# Heritage Formal Referral Response

<b>Officer:</b>	Nish Goonetilleke
<b>Council Reference:</b>	PHRF23/0217
<b>Address:</b>	300/658 Church Street, Cremorne VIC 3121
<b>Proposal:</b>	Heritage Victoria Referral – Partial demolition, alterations, and additions to the former Richmond Power Station
<b>Relevant Overlays</b>	<b>Heritage Grade:</b> Victorian Heritage Register  Heritage Overlay – Schedule 279 (HO279) (Northern-portion): Victorian Heritage Register H1055  Design and Development Overlay – Schedules 1-J & 5 (DDO1-J & DDO5)
<b>Yarra Planning Scheme References</b>	<ul style="list-style-type: none"><li>• Clause 15.03 Heritage</li><li>• Clause 21.05-1 Built Form (Heritage)</li><li>• Clause 22.02 Development Guidelines for sites subject to the Heritage Overlay</li><li>• Clause 43.01 Heritage Overlay</li><li>• Clause 59.07 Applications Under a Heritage Overlay</li></ul>
<b>Comments Sought:</b>	Heritage Victoria Referral – URGENT
<b>Disclaimer:</b>	Council’s Heritage Advisor provides the following information which is based on the information provided in the referral request memo referenced above.

Figure 6. Axonometric illustration showing the age of the different building components. Source: Heritage Impact Statement, Former Richmond Power Station, Bryce Rawthorn November 2023.

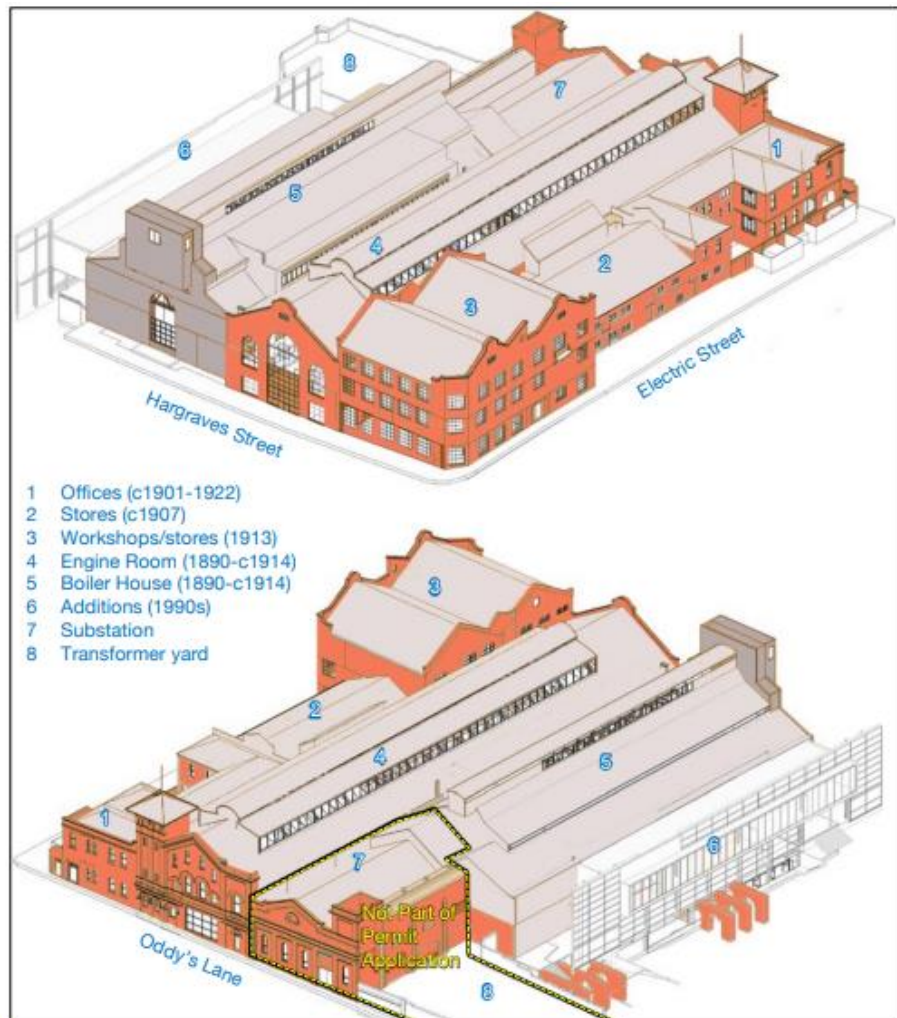
It is recommended that the proposed extent of demolition impacting the Boiler House (1890-c1914) (Building 5) and the Stores (c1907) (Building 2) is reconsidered. It is suggested that the level of intervention proposed for these two buildings will negatively affect the cultural heritage significance of the place. It is submitted that plans to externally re-clad the Boiler House in glass and convert the Stores into an open-air courtyard are incompatible with existing fabric and require a level of irreversible adaptation and change, particularly as experienced from the public realm.

It is recommended that proposed intervention affecting original external fabric associated with the Boiler House and the Stores is revised to ensure the integrity and significance of these buildings can be maintained. As noted in the CMP (as referenced in the HIS provided), the architectural interest of the complex primarily rests in the largely intact exteriors, principally the west and east façade. It is important that the form and architectural character of the valued facades remains legible. It is submitted that the proposed works oppose this intention.

It is recommended that proposed new works to the Boiler House (Building 5) and the Stores (Building 2) are reconsidered. It is submitted that plans to 'reimagine' the Boiler House into a glass house structure and the Stores into a landscaped courtyard requires a level of irreversible intervention that will detract from the integrity and condition of these buildings and more broadly impact the cultural heritage significance of the complex as a whole. It is recommended that a greater level of original fabric is retained associated with both buildings and a greater level of restoration and reconstruction is proposed, particularly as it relates to external elevations as experienced from the public realm.

It is recommended that the full elevations to Electric Street (north) and Hargreaves Street (east) are maintained and restored/reconstructed to the greatest extent possible, noting that there is more capacity for adaptation and change associated with the south elevation in place of the 1990s new additions. It is recommended that the full elevation of the Boiler House (fronting Hargreaves Street) is restored back to its original appearance (e.g. corrugated iron cladding) and the roof form and external windows associated with the Stores (fronting Electric Street) are maintained.
